CENTRE POINT

WHITE LION HOUSE ROOF
SUPPLEMENTARY INFORMATION TO APPLICATION
FOR MINOR MATERIAL AMENDMENT

PLANNING PERMISSION: 2013/1957/P
LISTED BUILDING CONSENT: 2013/1961/L

DOCUMENT 600-7591

Figure 1
Approved CPW roof plan zoomed in from Drawing: 552-19413-CPA PL2 (Not to Scale)
Proposed MMA CPW roof plan zoomed in from Drawing: 552-19413-CPA PL3 (Not to Scale)

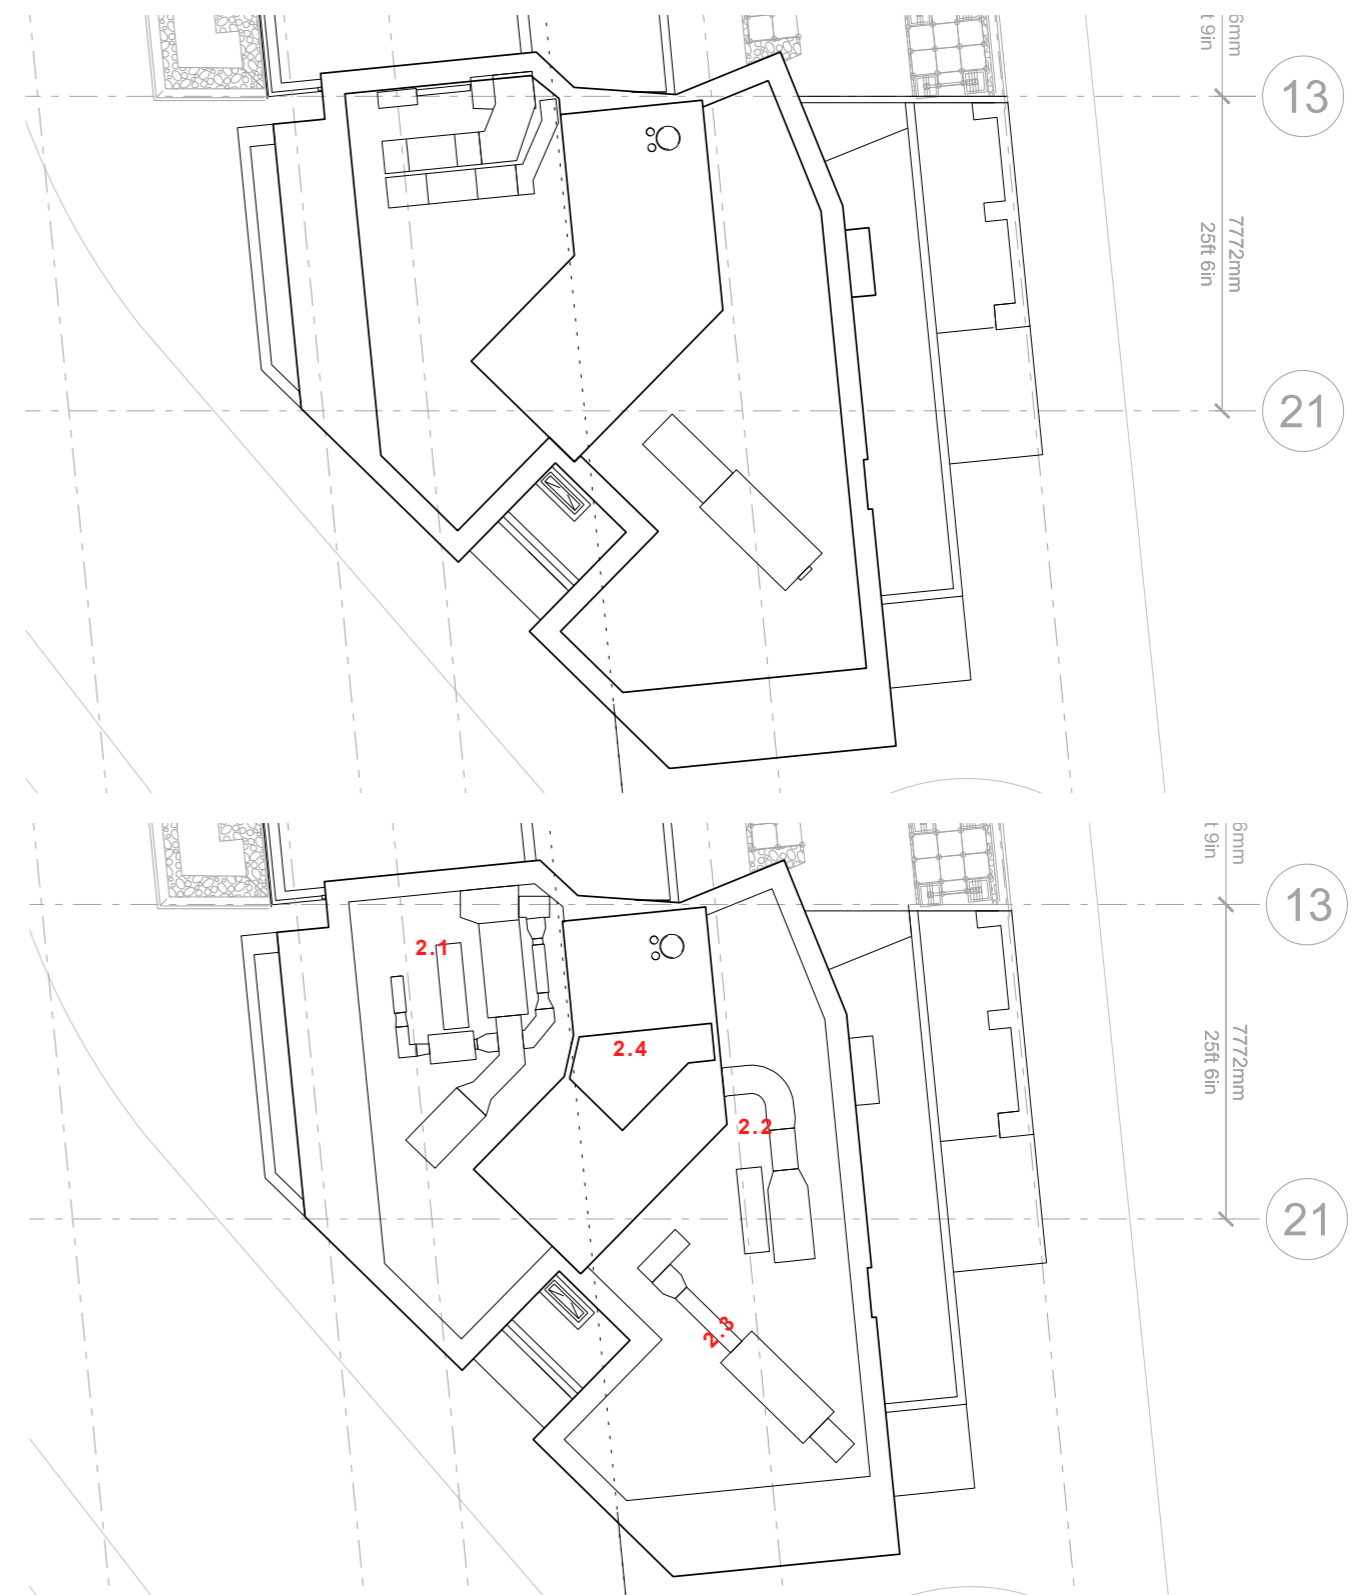
Sound attenuation in ducts is primarily a factor of the length of the duct. We have developed the mechanical engineering design to minimise the size of the ducts. The length of the ducts cannot be further reduced without reducing the acoustic performance. The height of the ducts is constrained to 1170mm above roof level; the parameter previously set. This is minor in nature and will not be apparent from key, approved street views as described below.

In balance with the length of sound attenuation needed and the position of the openings to the roof the plant is kept away from the parapet edges as far as possible which also allows for safe access around the perimeter of the building using the fall prevention system.

The importance of the roofscape is recognised. The the plant has been redesigned so that the combined tumble dryer fan and ventilation shaft fan have been relocated within the building. These measures in turn reduce the amount of inspection and maintenance work required at roof level.

The enclosures are roofed to improve views from above.

The rationale of the arrangement is to position the plant so that it relates to the primary geometry of the building; the two grids. The arrangement of the concrete paviors set amongst the Scottish beach pebble ballast is also aligned to the building geometry.

The same overall amount of enclosure is proposed as the approved scheme but due to the lengths of the attenuation, the plant cannot be further compacted to fit inside the enclosure. Extending the enclosures further would increase their bulk so that they become more visible from street level and more dominant at upper level views. With this in mind the design approach for the approved scheme for a compact primary enclosure where the height is required and secondary, lower installation elsewhere is maintained albeit extended.

Base fixings will be concealed by ballast and the duct and plant cladding will be factory painted to match the primary louvred enclosure.
